# **ADDENDUM NUMBER: ONE [1]**

PROJECT: Provalus Whiteville

DATE: November 20, 2024

Drawings and Project Manual dated <u>October 30, 2024</u>, for this project are hereby modified, corrected, or supplemented as follows:

FINISH PLAN - FIRST

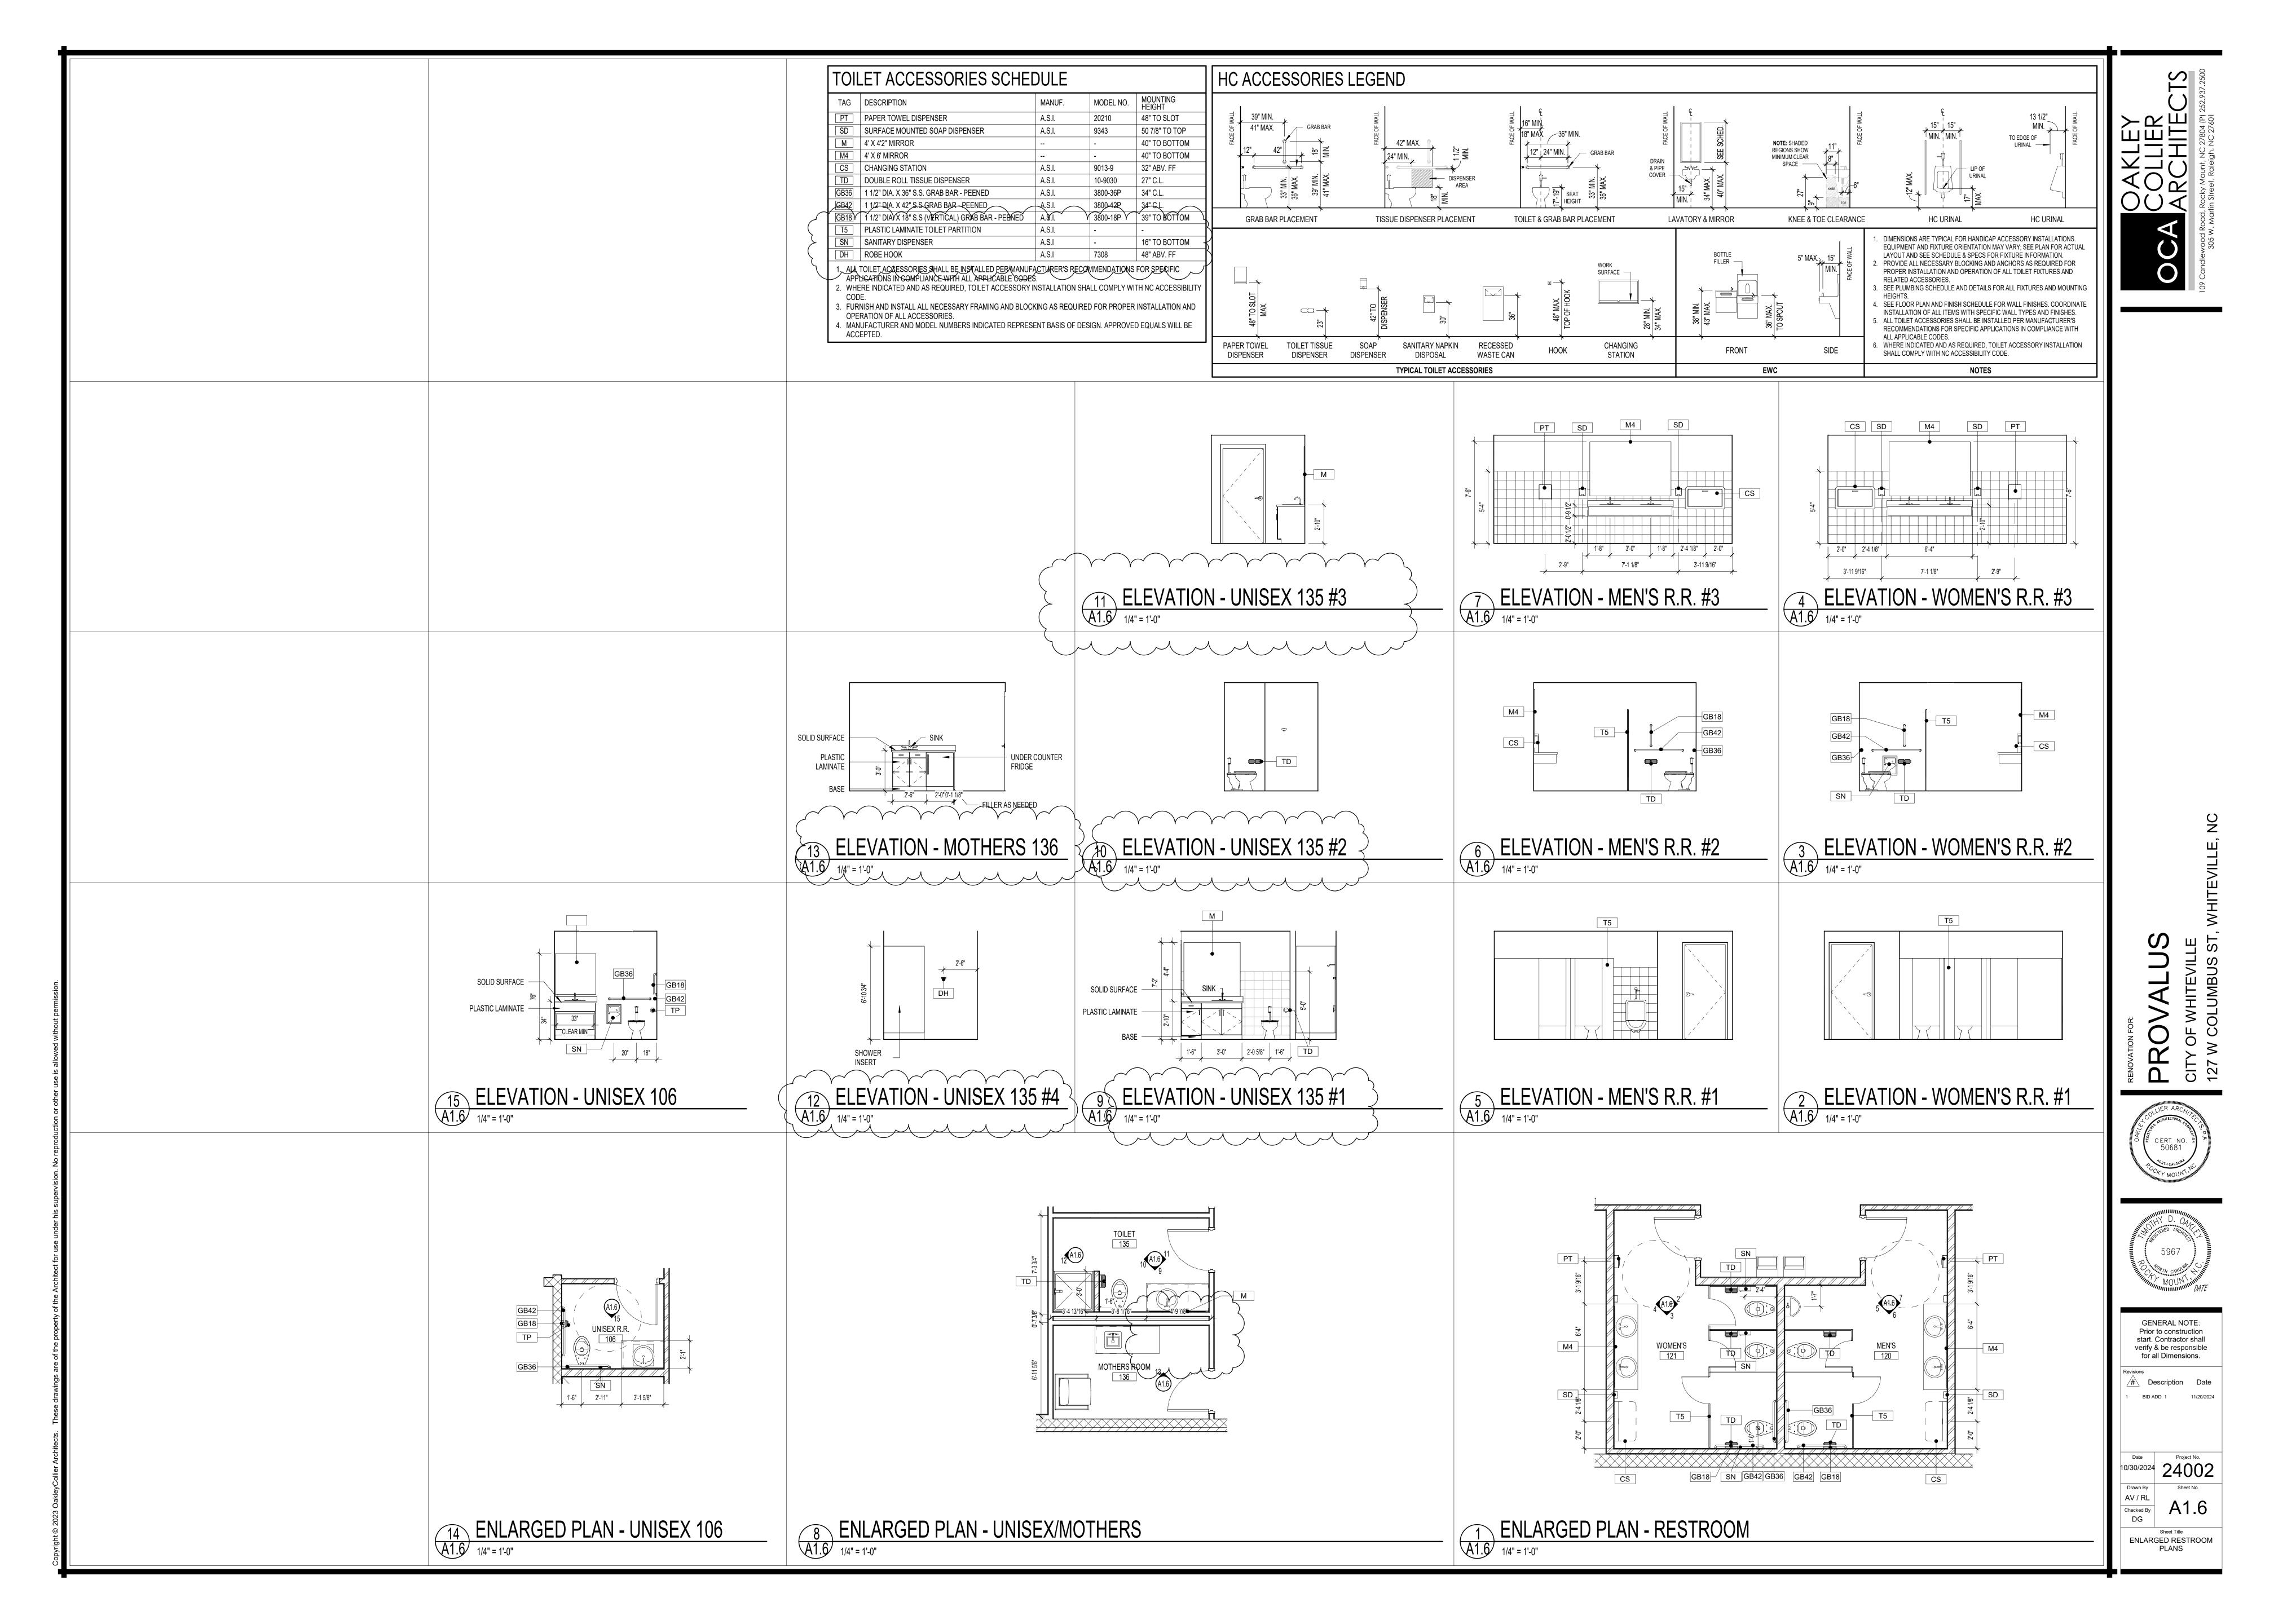
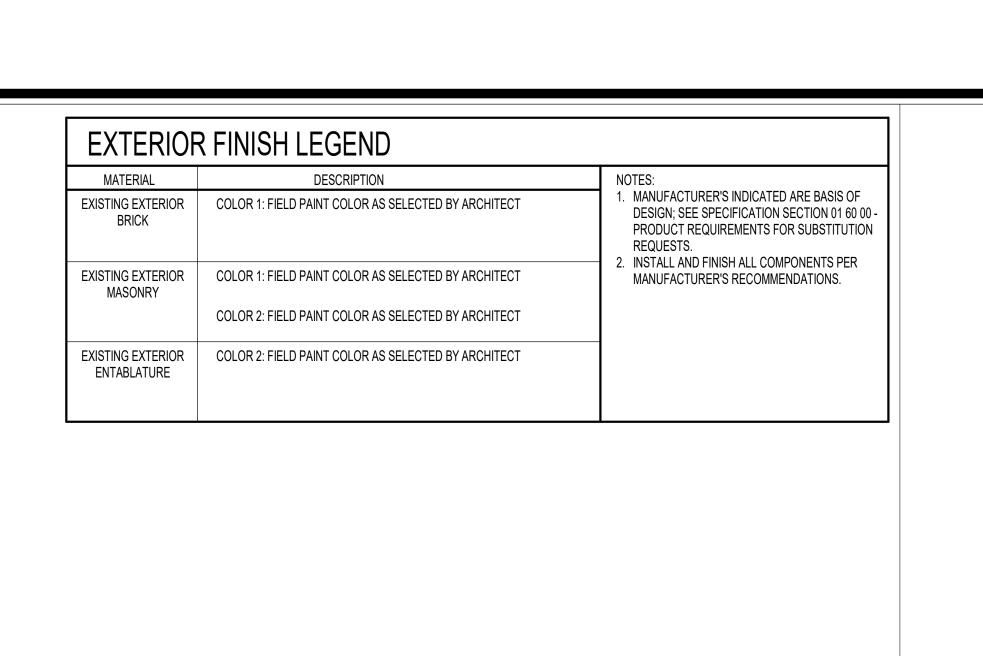
Item 7 Revision Sheet A1.3 – Finish Plan-First Floor

Finish Plan Notes updated to include new Note 10

Finish Schedule updated to indicate Break Room 118 flooring as LVT-1 Finish Schedule updated to indicate Exec Conf 131 flooring as LVT-1
